**WoO Craftsman Sprint Series 2018 Rules Bulletin #2**

**15.5.U**

**Approval of optional additional tubing to support top rail in driver's compartment.**

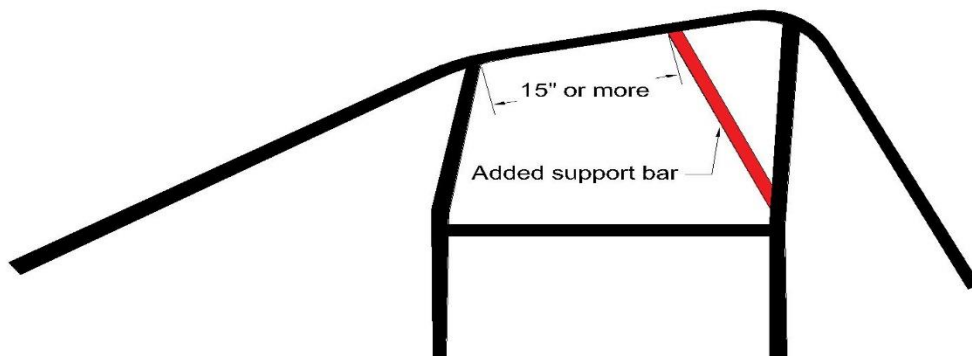
An optional support bar may be added to the right and left hand side of the driver's compartment with the following specifications:

1. Tubing for the optional support bar may only be attached to the rear upright near the hip rail (may not be attached to the hip rail) and the top rail. (See drawing below)
2. Tubing must be 1 3/8" X .083" or greater ASTM4130 normalized steel or equivalent material.
3. The attachment point on the top rail may not be less than 15" from the front upright where it attaches to the top rail. (See drawing below)
4. No additional body work may be attached to the new tubing. The body work on the right side must maintain the current 10" x 21" opening per the World of Outlaws Craftsman Sprint Car Series rule book 15.7.J
